Access Compliance Report

Public Rights-of-Way

(Curb Ramps)

Intersection ID: 17486	Main Street: SELWYN_AV	Cross Street: STERLING_RD	Location: SE
ADA ID: 7DBECF9BEB57	Ramp Type: PerpDiag	Initial Pass/Fail: Fail	Overall Compliance: No
Severity Score: 12.5			
Codes/Mitigation Info/Possible Solution		Field Measurements/Component Compliance

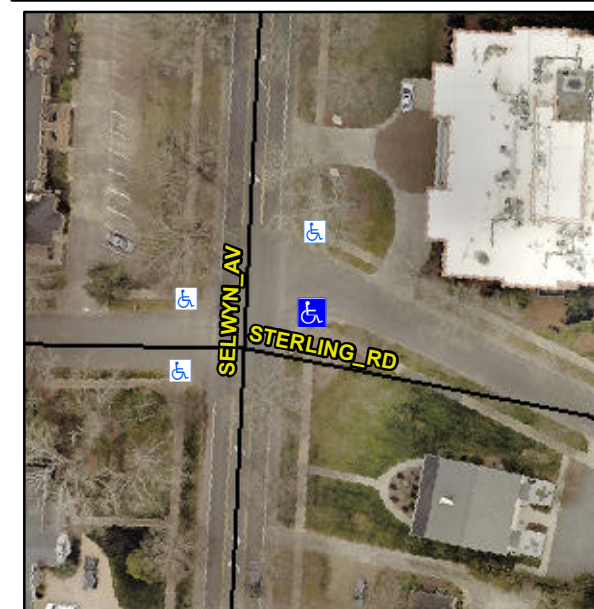
PROW/ADA:

Not Found, R304.2.2

Compliance	Description	Data	Compliance	Description	Data
N/A	Ramp Length (in)	96.0	No	Ramp Slope (%)	9.3
Yes	Ramp Width (in)	72.0	Yes	Ramp XSlope (%)	1.4
N/A	Flare Type LT	N/A	N/A	Flare Type RT	N/A
N/A	Flare Slope LT (%)	N/A	N/A	Flare Slope RT (%)	N/A
N/A	Flare Traversable LT?	N/A	N/A	Flare Traversable RT?	N/A
N/A	Landing Length (in)	N/A	N/A	DWS Provided?	N/A
N/A	Landing Width (in)	N/A	N/A	DWS Contrast?	N/A
N/A	Landing Slope (%)	N/A	N/A	DWS Length (in)	N/A
N/A	Landing X Slope (%)	N/A	N/A	DWS Full Width?	N/A
N/A	Landing Curb? (Y/N)	N/A	N/A	DWS Offset (in)	N/A
N/A	Shared Landing?	N/A			
N/A	Gutter Ponding?	N/A	N/A	Gutter Slope (%)	N/A
N/A	Gutter Lip Ht (in)	N/A	N/A	Gutter X Slope (%)	N/A
N/A	Painted X Walk1?	No	N/A	Painted X Walk2?	No
	X Walk 1 Direction	To N		X Walk 2 Direction	To NW
N/A	X Walk 1 Width (in)	N/A	N/A	X Walk 2 Width (in)	N/A
	X Walk 1 Slope (%)	1.3		X Walk 2 Slope (%)	3.8
	X Walk 1 X Slope (%)	2.0		X Walk 2 X Slope (%)	1.6

Possible Solutions:

Remove & Replace Curb Ramp With Two New Directional Ramps or Equivalent.
